SECTION 00 90 01
BIDDING AND CONTRACT REQUIREMENTS
ADDENDUM NUMBER 1

Issued: May 27, 2025

Re: ADDENDUM NUMBER (1) TO THE BIDDING DOCUMENTS FOR

McHenry County College
Engagement Hall
Architect's Project Number: 24-027

SHEET NUMBER:
MD1.12

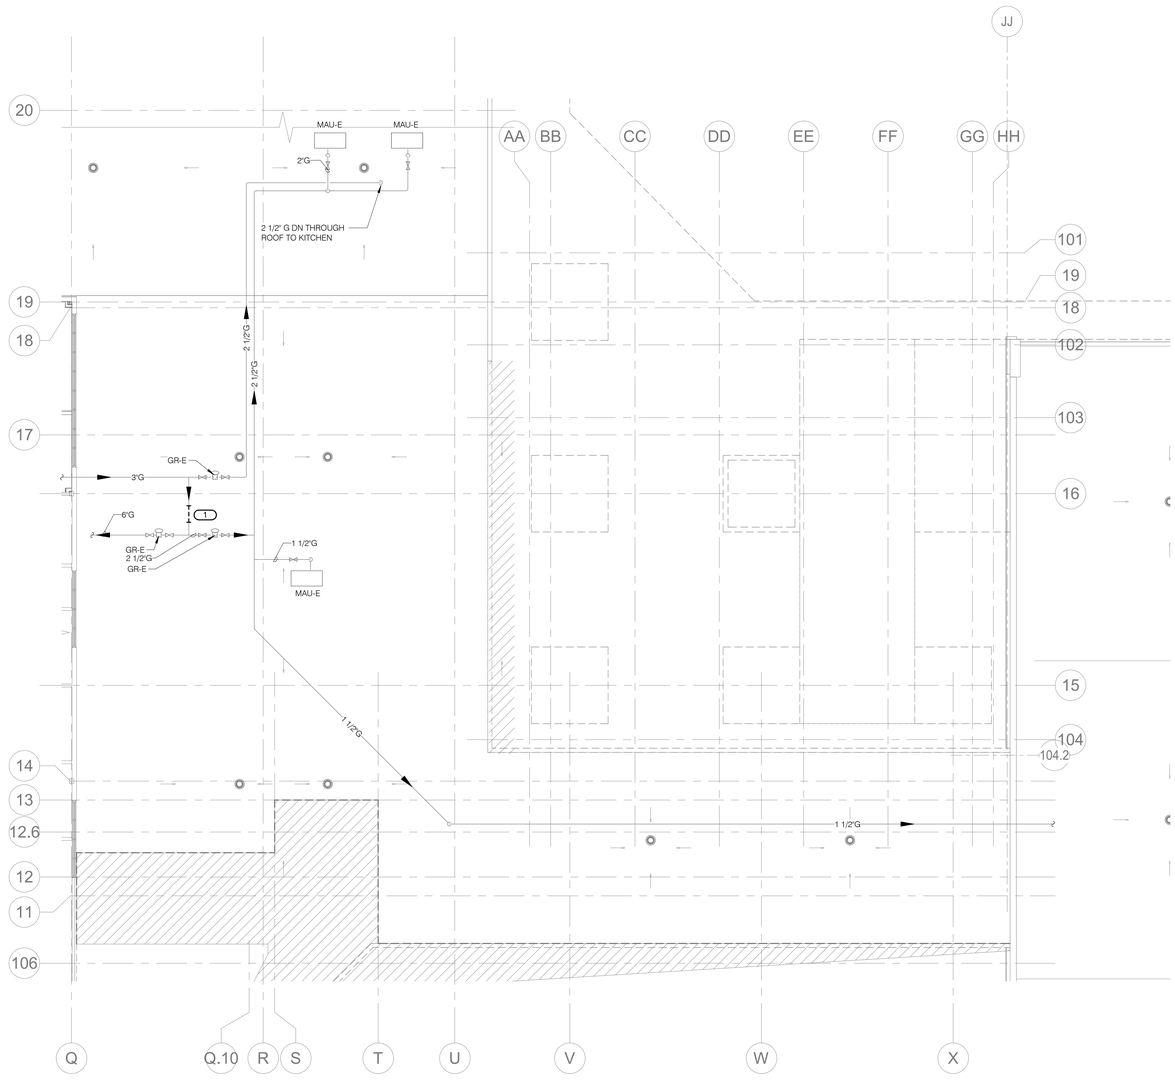
5. MD1.12 – ROOF PLAN DEMOLITION – MECHANICAL
   A. **ADD** the attached sheet in its entirety.
6. M1.01 - FLOOR PLAN – PIPING
   A. **ADD** existing HVAC Piping and Mechanical Equipment in dining hall.

SHEET NUMBER:
M1.11

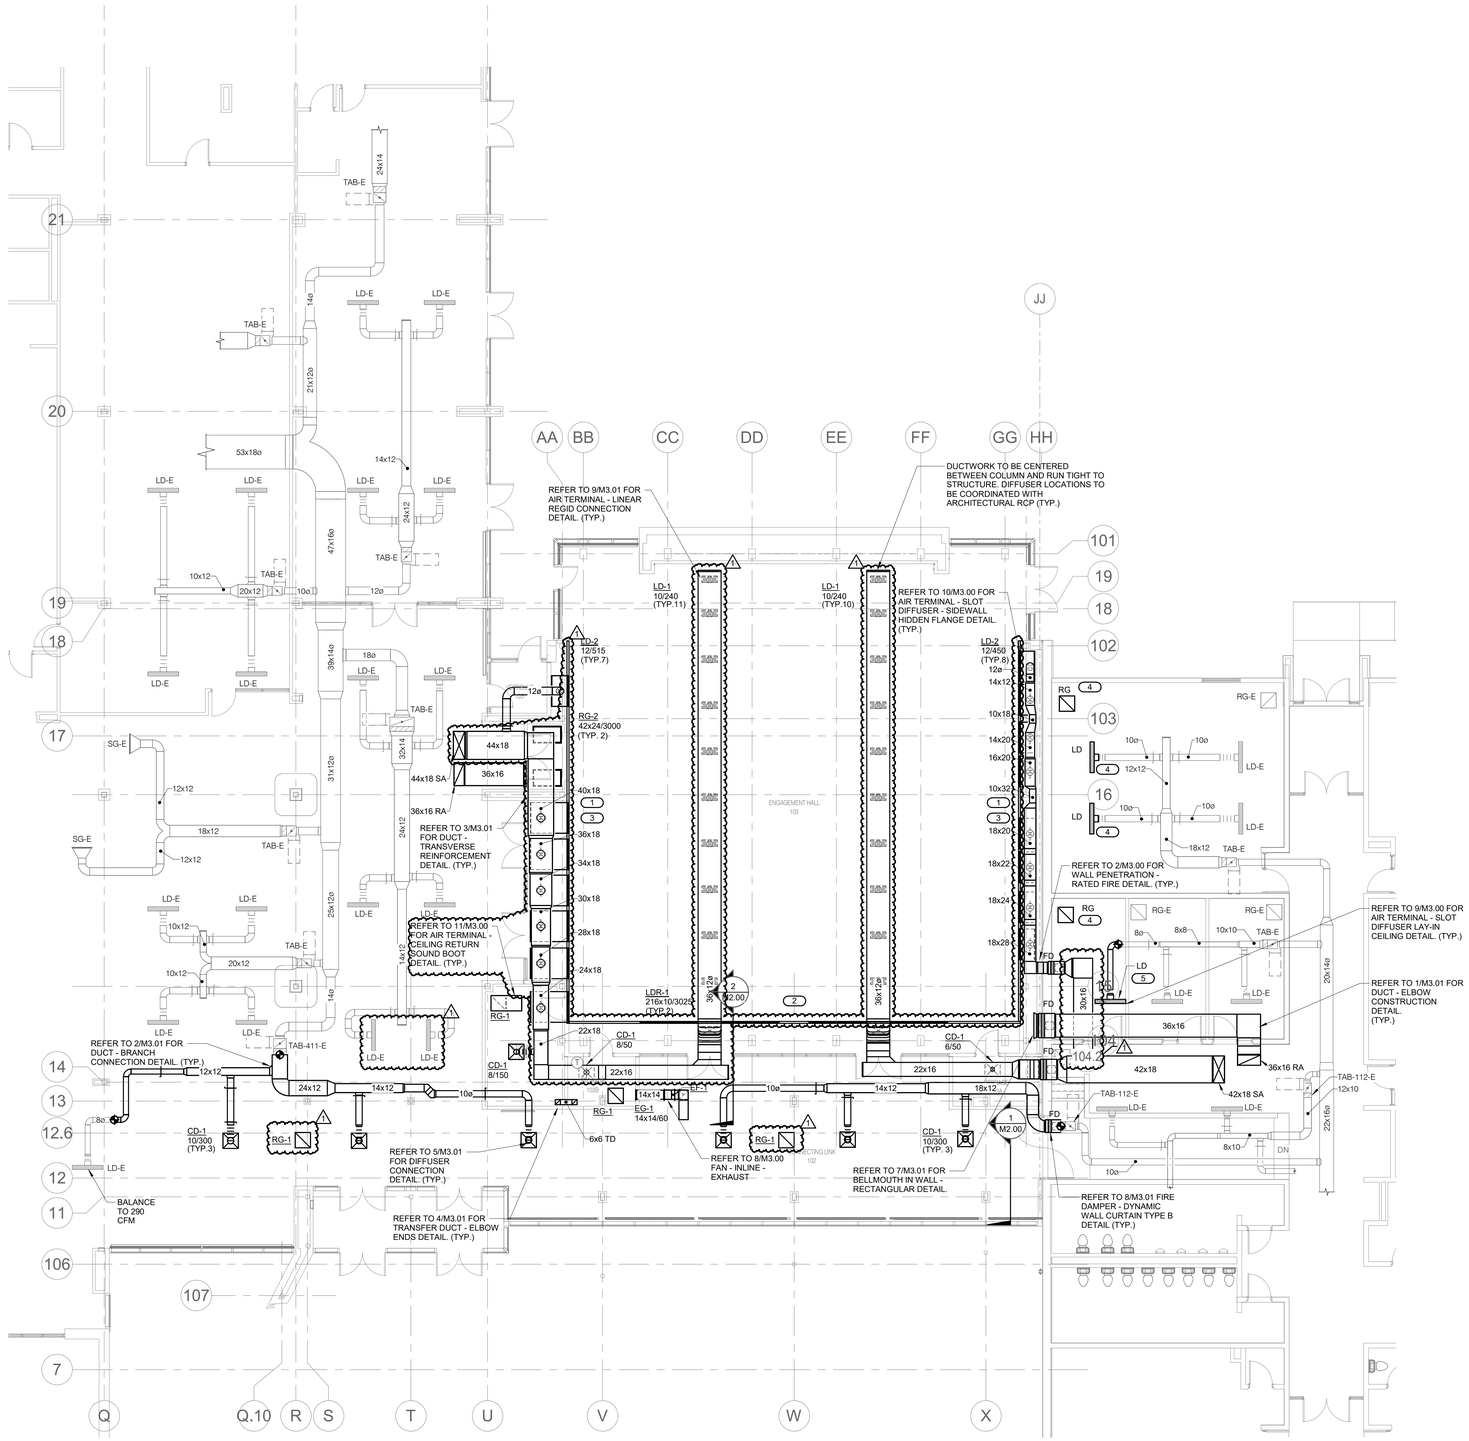
7. M1.11 - FLOOR PLAN - VENTILATION
   A. **REVISE** Keynote 1 and 2. Extending Supply and Return for continuous look around the space.
   B. **REVISE** Sidewall diffusers to show continuous look around space.

SHEET NUMBER:
P1.00

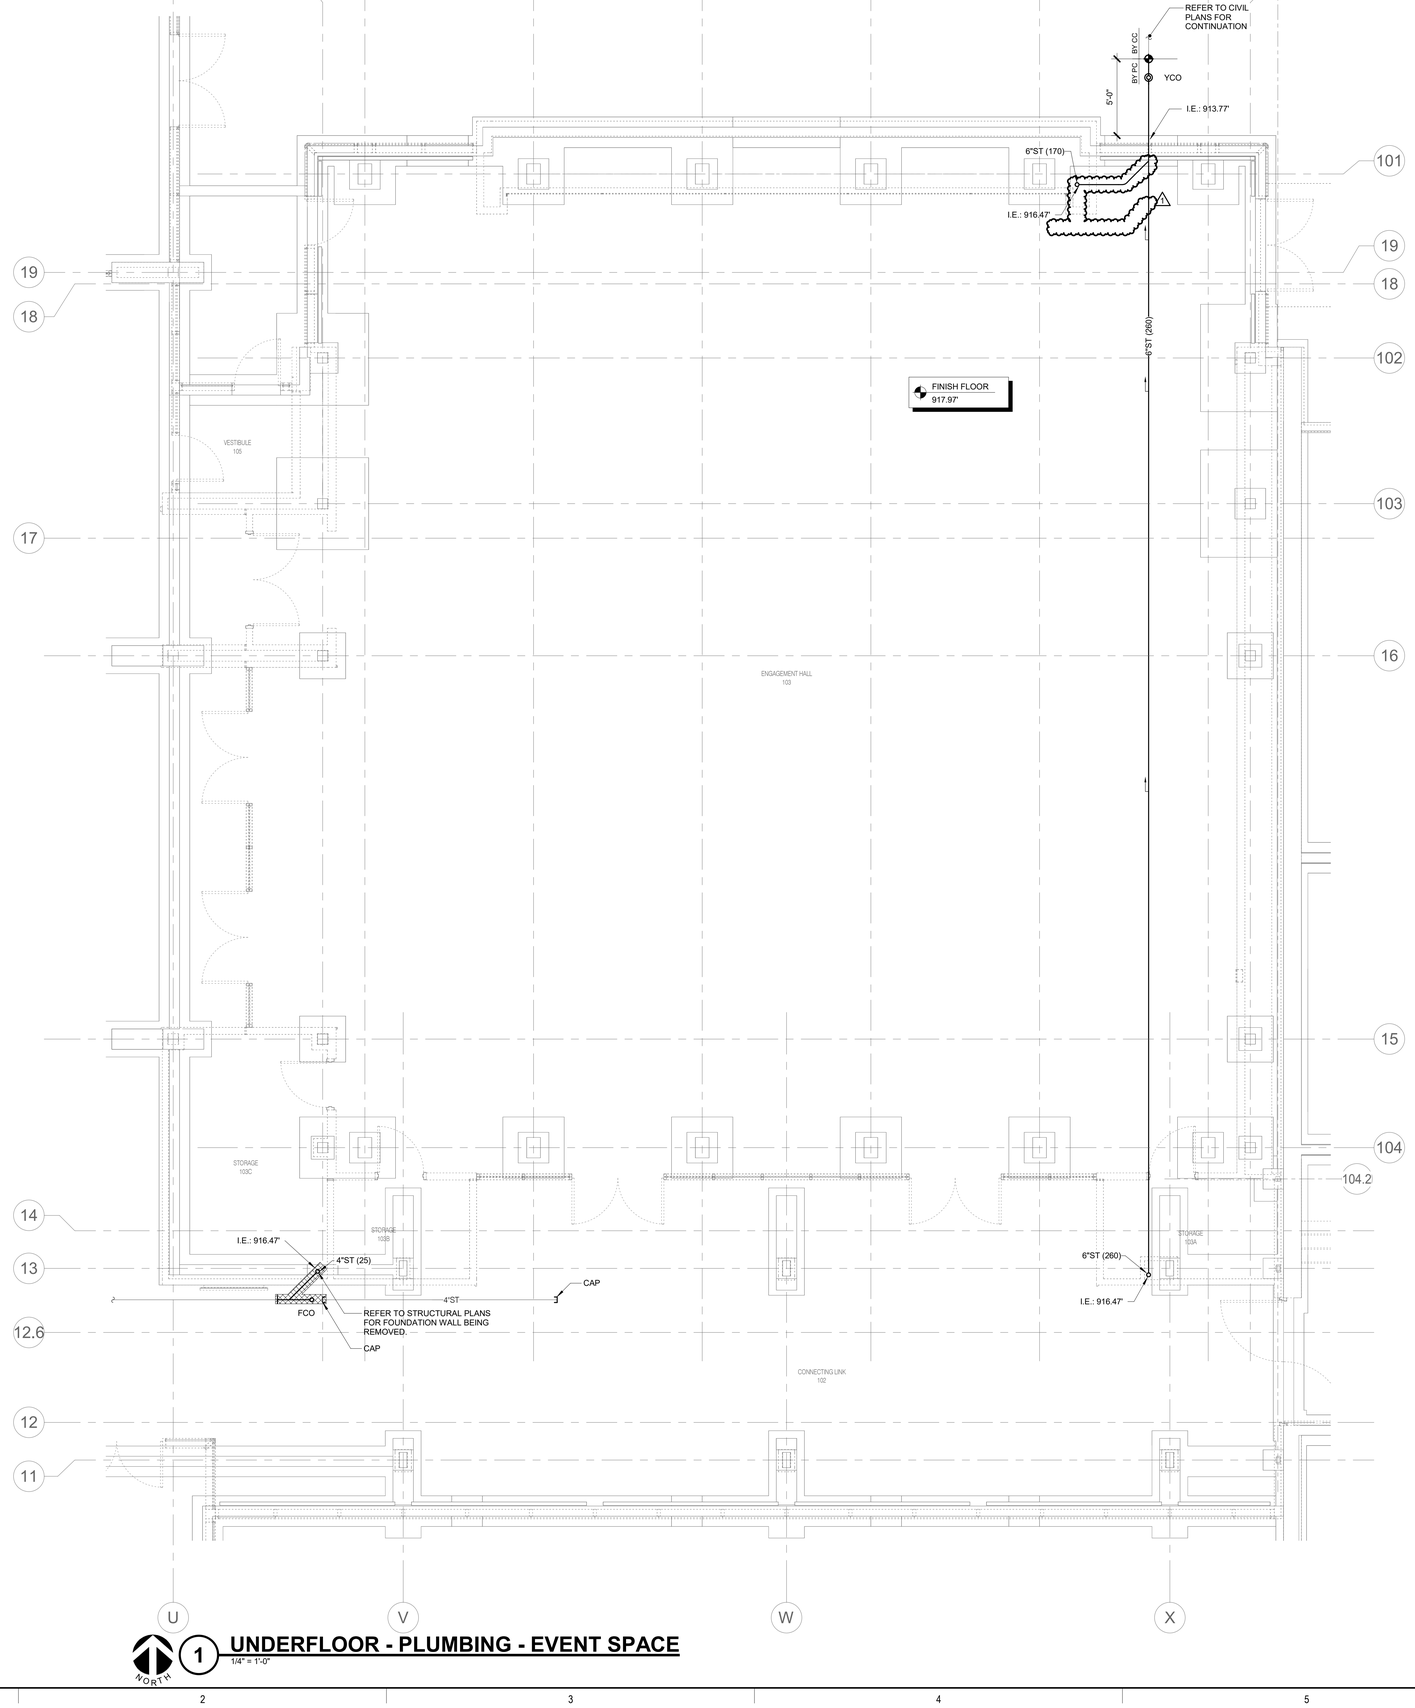
PLUMBING
1. P1.00 - UNDERFLOOR - PLUMBING - EVENT SPACE
    A. **DELETE** FCO
    B. **REVISE** Primary storm piping to route directly into main.
2. P1.01 - FLOOR PLAN - PLUMBING - EVENT SPACE:
    A. **REVISE** primary/secondary storm piping in northern chase.
    B. **DELETE** Floor Cleanout
3. P1.02 - ROOF PLAN - PLUMBING
    A. **REVISE** Roof Drain Tags

SHEET NUMBER:
F1.01

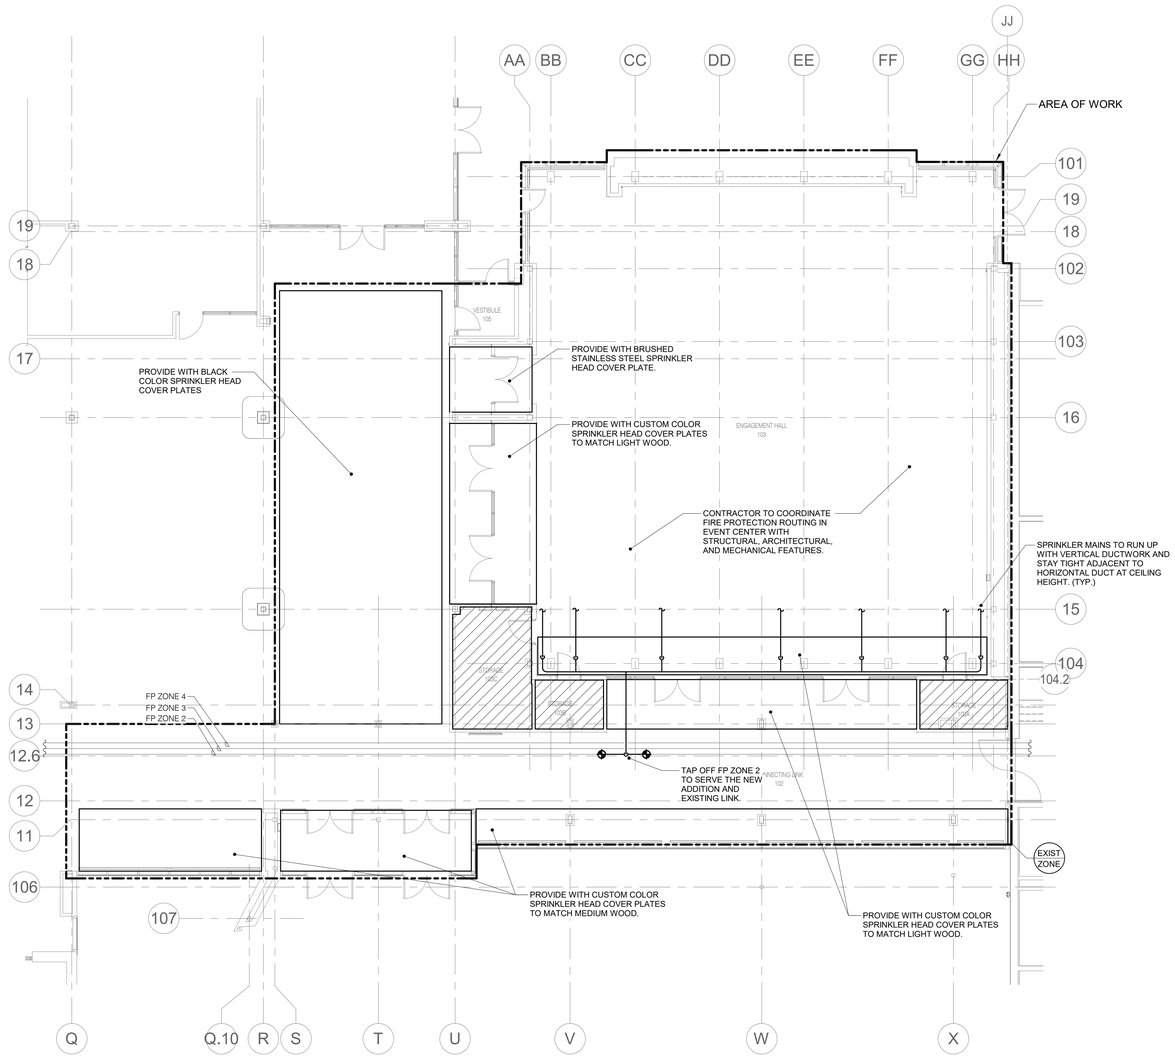
FIRE PROTECTION
1. F1.01 - FLOOR PLAN - FIRE PROTECTION
    A. **ADD** sheet note to provide hangers and support in engagement hall 103 with architectural wooden structure.
2. F2.00 - FIRE PROTECTION DETAILS
    A. **ADD** Detail for exposed sprinkler head.

SHEET NUMBER:
E1.00

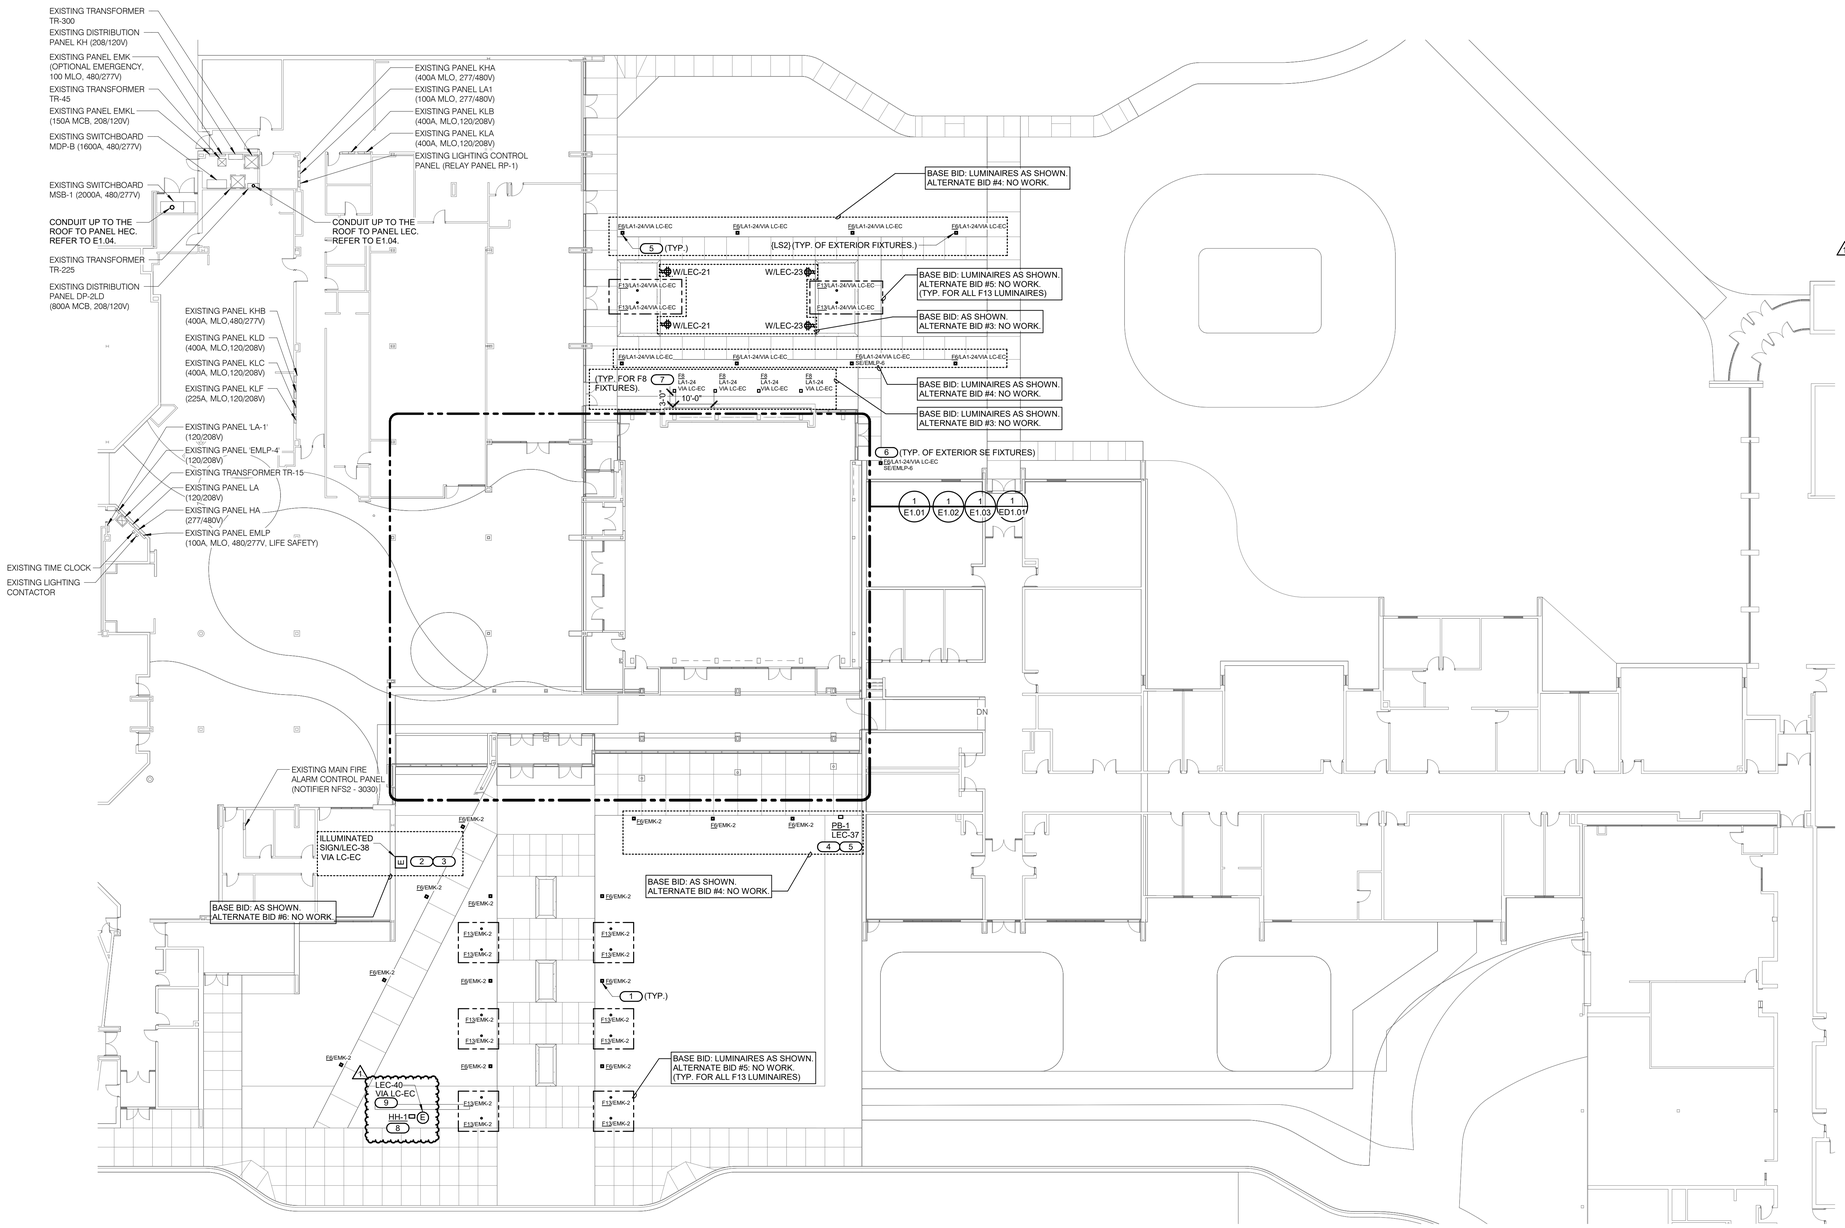
ELECTRICAL
1. E0.00 – ELECTRICAL COVERSHEET
    A. **ADD** handhole symbol in the electrical symbol list.
2. E1.00 – OVERALL PLAN – ELECTRICAL
    A. **ADD** handhole “HH-1” for future sign installation.
    B. **ADD** keynote #8.
    C. **ADD** keynote #9.
3. E1.02 – FLOOR PLAN – POWER
    A. **ADD** 120V connection in Connecting Link 102 to exhaust fan “EF-1”. Connected to 20A/1P circuit LEC-39.
4. E3.01 – ELECTRICAL DETAILS
    A. **ADD** sheet E3.01 – Electrical Details.
    B. **ADD** Exterior Handhole Detail.
5. E6.00 – ELECTRICAL PANEL SCHEDULES
    A. **REVISE** RTU-2 wire size and circuit breaker size in Panel HEC schedule.
    B. **ADD** to Panel LEC schedule new EF-1 circuit load.
    C. **REVISE** in Panel LEC schedule circuit LEC-40 load description.

5 VIDEO WALL ELEVATION
3/4" = 1'-0"

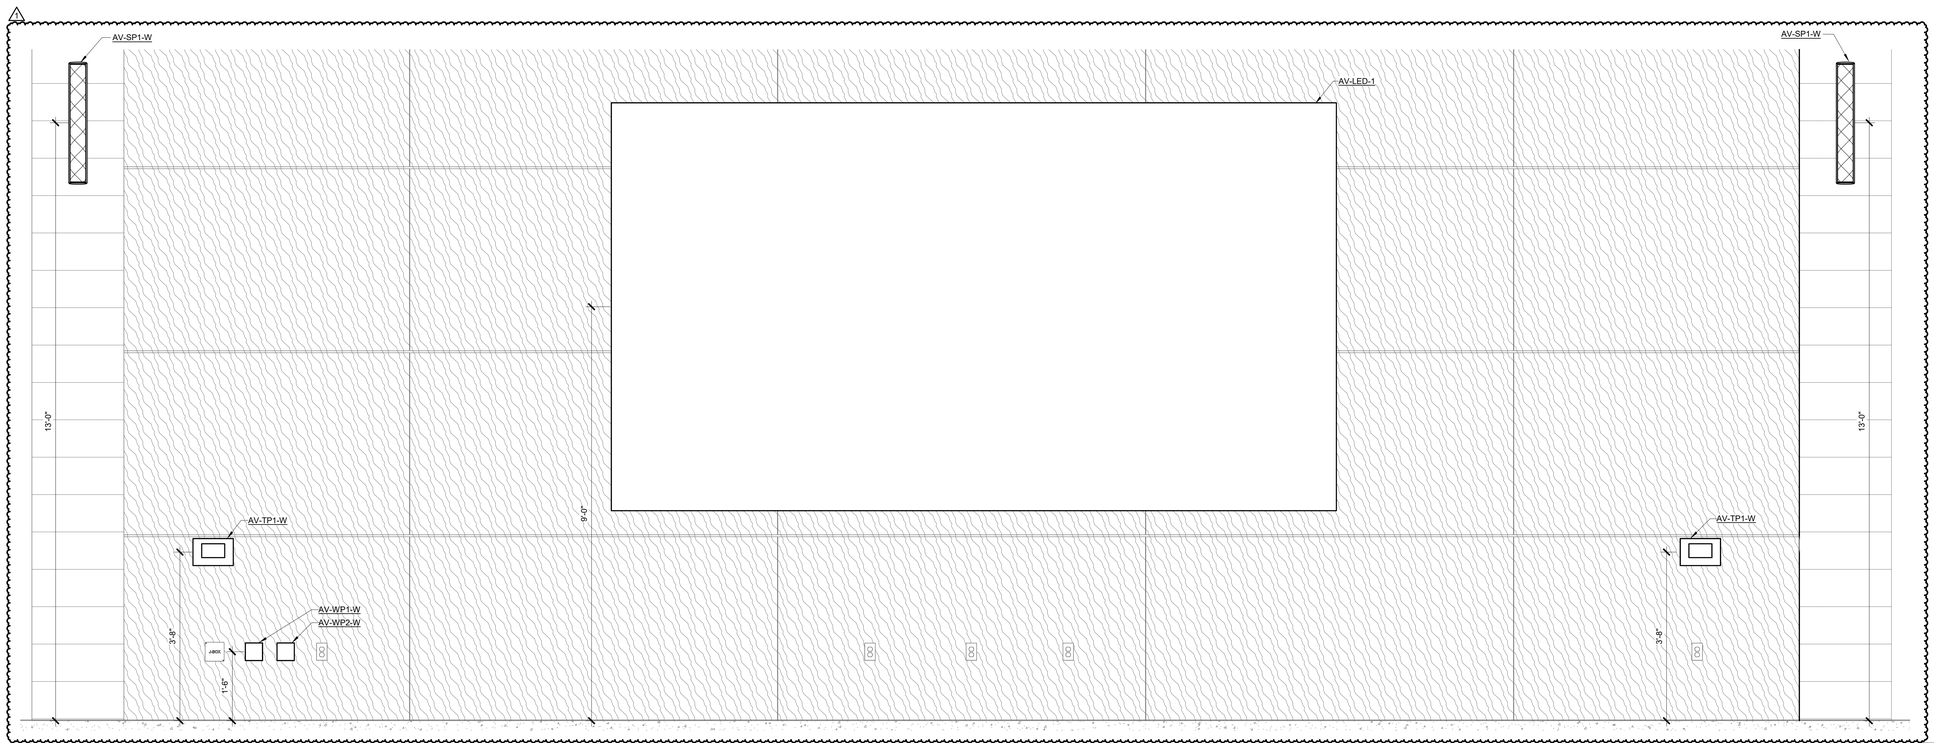
TECHNOLOGY
1. T0.00 – TECHNOLOGY COVERSHEET
    A. **ADD** AV FUNCTIONAL DIAGRAM KEY
    B. **REVISE** TECHNOLOGY SYMBOL LIST.
    C. **REVISE** TECHNOLOGY GENERAL NOTES.
2. T1.01 – FLOOR PLAN – TECHNOLOGY – ENGAGEMENT HALL
    A. **REVISE** sheet title to ENGAGEMENT HALL in lieu of EVENT SPACE
    B. **REVISE** Detail #1 title to ENGAGEMENT HALL in lieu of EVENT SPACE
    C. **ADD** Elevation 5/T2.00 in ENGAGEMENT HALL.
    D. **ADD** keynote#2 symbol in ENGAGEMENT HALL.
    E. **REVISE** keynote#2 description on sheet.
3. T2.00 – TECHNOLOGY ENLARGED PLANS
    A. **DELETE** panel AV-WP3-R and AV-WP4-R from detail#2 AV CABINET ELEVATION.
    B. **ADD** panel AV-MPP-1 in detail#2 AV CABINET ELEVATION.
    C. **ADD** detail #5 VIDEO WALL ELEVATION.
4. T3.00 – TECHNOLOGY DETAILS
